# UNITED STATES PATENT AND TRADEMARK OFFICE

APPLICATION NO.	FILING DATE	FIRST NAMED INVENTOR	ATTORNEY DOCKET NO.	CONFIRMATION NO.
10/765,636	01/27/2004	Gerald R. Savicki JR.	905P164	2271
44564	7590	02/25/2005	EXAMINER	
BOND, SCHOENECK & KING, PLLC 10 BROWN ROAD, SUITE 201 ITHACA, NY 14850-1248			KLAUS, LISA NHUNG	
			ART UNIT	PAPER NUMBER
			2832

**Office Action Summary**

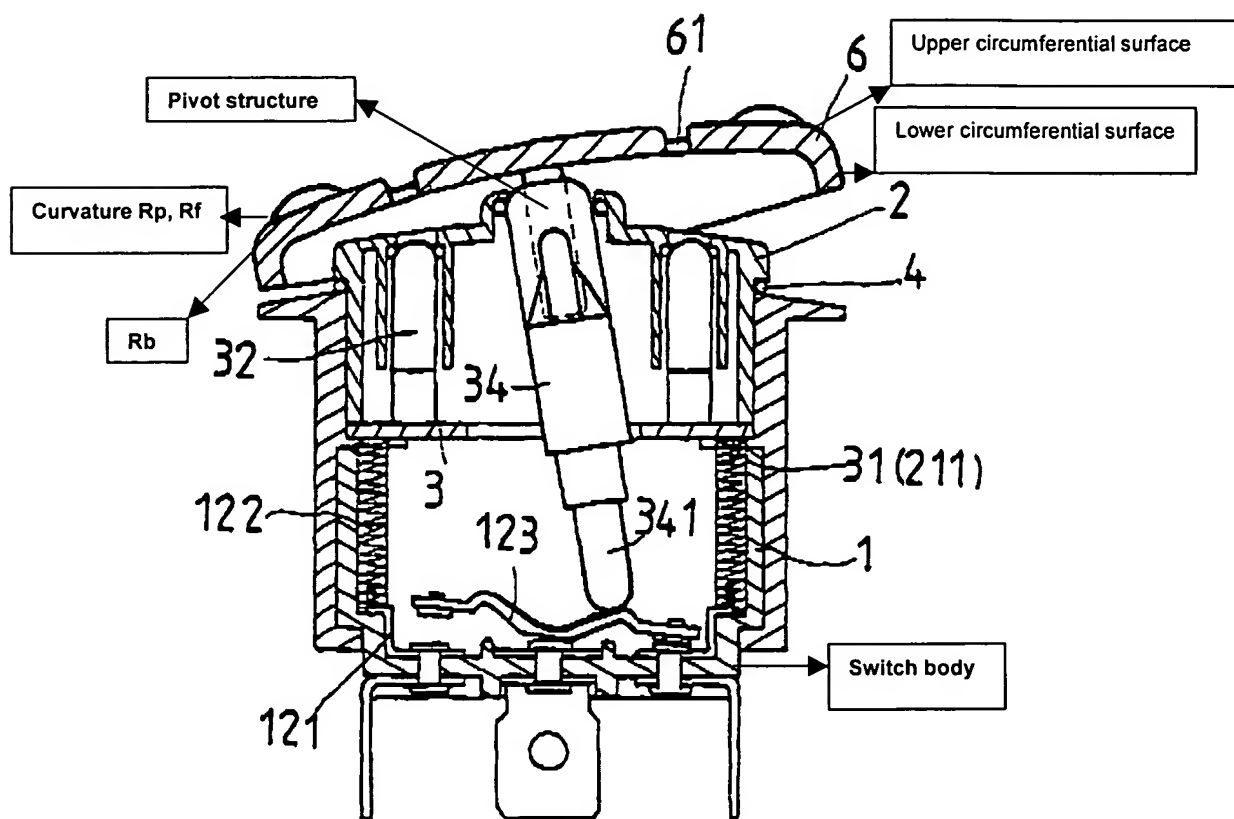
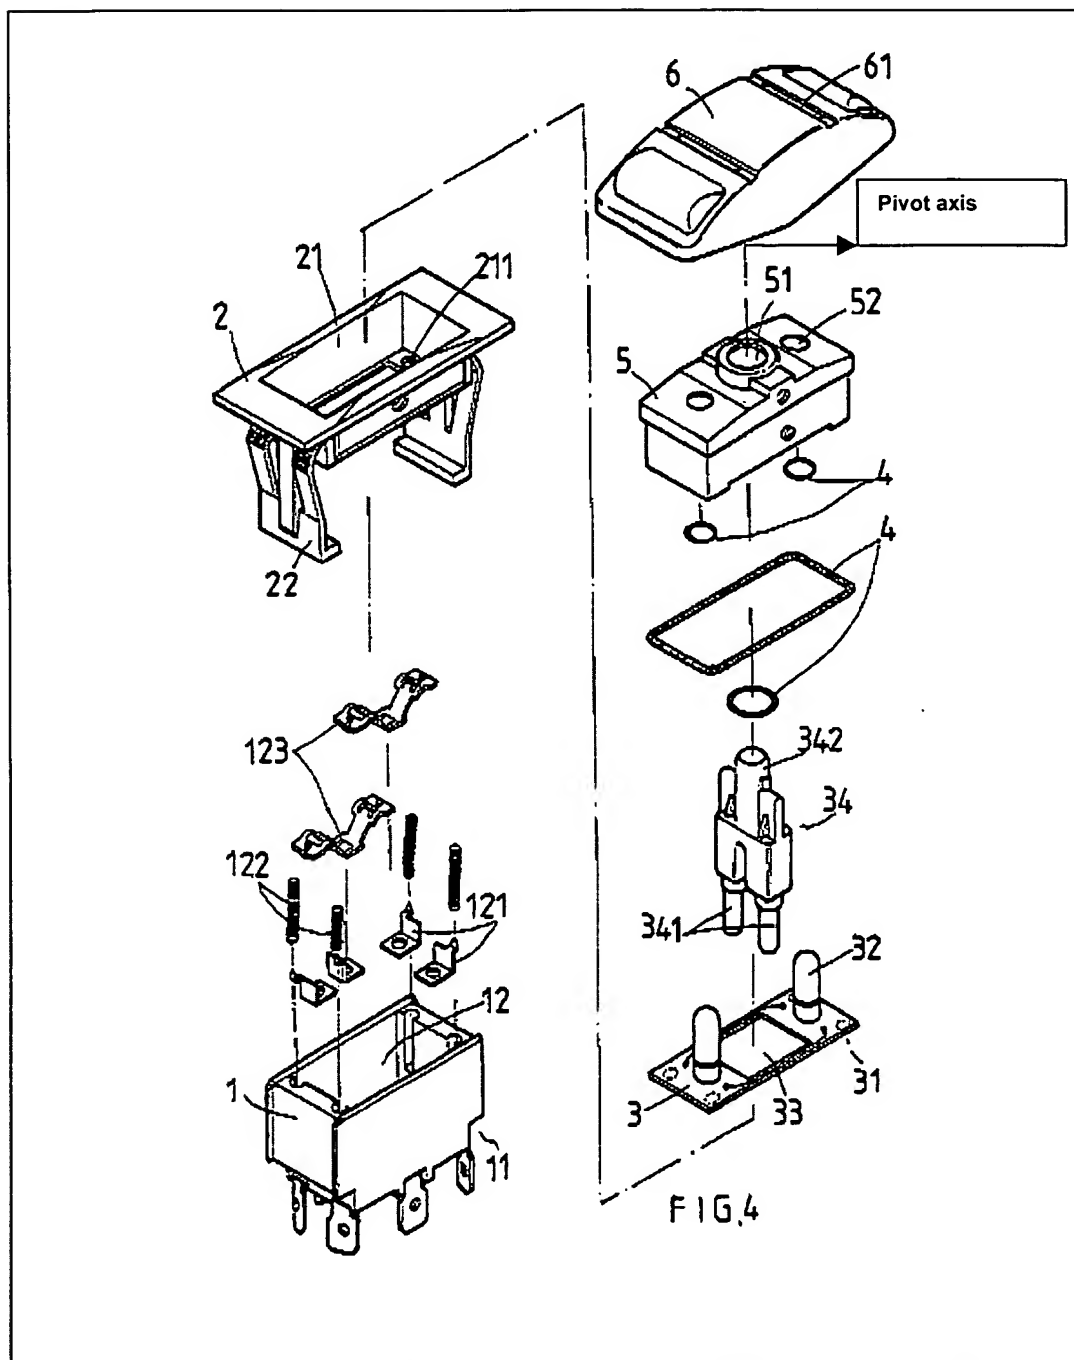
Yei discloses a rocker switch comprising:

- a switch body 1 including switch contact (see attachment);
- a frame 5 attached to the switch body;
- a paddle 6 for actuating the switch contacts;
- wherein the paddle has a pivot structure cooperatively engageable with a portion of the frame for selective rotational movement around a pivot axis (see the attachment) between a limited forwardly-tilted position and a limited rearwardly-tilted position;
- wherein the paddle has a uni-convex cylindrical exterior surface with a curvature, Rp (see the attachment);
- the paddle 6 has an actuating structure integrally attached to a rear surface thereof having a distal end that operationally enables an open-switch condition and a closed-switch condition;
- the paddle 6 has an upper and a lower circumferential surface (see the attachment) each having a curvature, Rb, the center of which originates along the pivot axis;

- the paddle 6 includes an indicia 61 for identifying one of a position of the paddle and an indication of the switch status;

- the indicia 61 is a surface indent.

Yei further comprises the paddle 6 includes an upper and a lower circumferential surface having a curvature, Rb (see the attachment), the center of which originates along the pivot axis.

FIG. 5

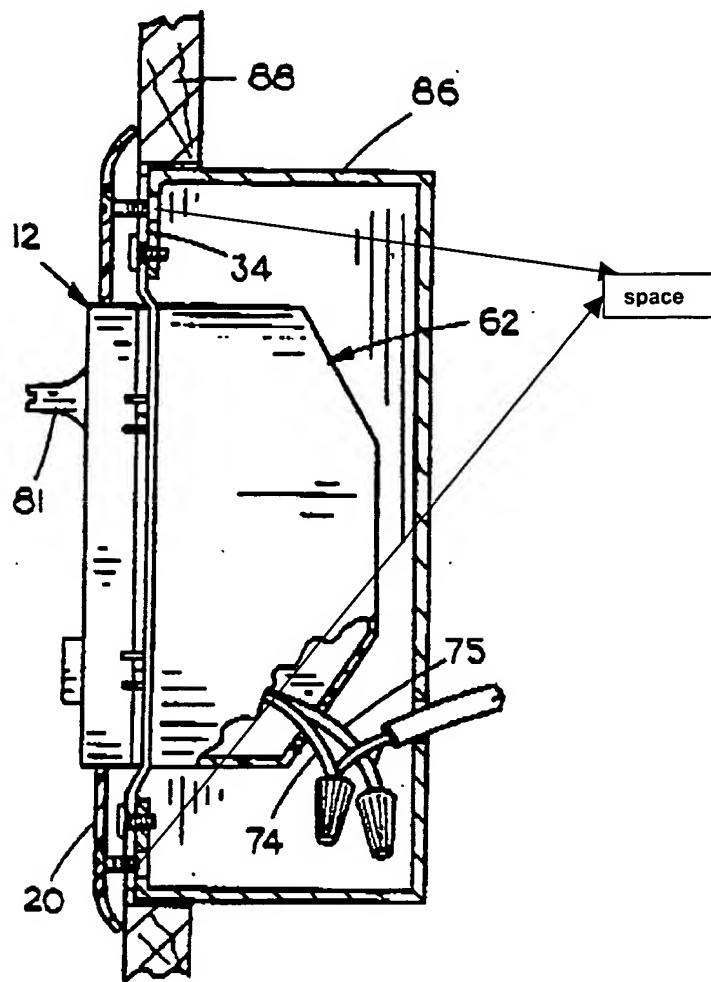
Swanson discloses a wall box dimmer comprising:

- a mounting trap 34 attached to the switch body 62;

- one of the upper and the lower circumferential surfaces 20 engages a space (see the attachment) intermediate a portion of the mounting strap 34 and a surface of the frame 86 in one of the forwardly-tilted position and the rearwardly-tilted position;

- the faceplate 12 in having an opening perimeter defined by upper and opposing lower inner surfaces and left and opposing right inner surfaces;

- the paddle 20 occupies the faceplate opening in an assembled condition;

- the axial center line of the faceplate opening and an axial centerline of the paddle 20 have a constant intersection point along the pivot axis.
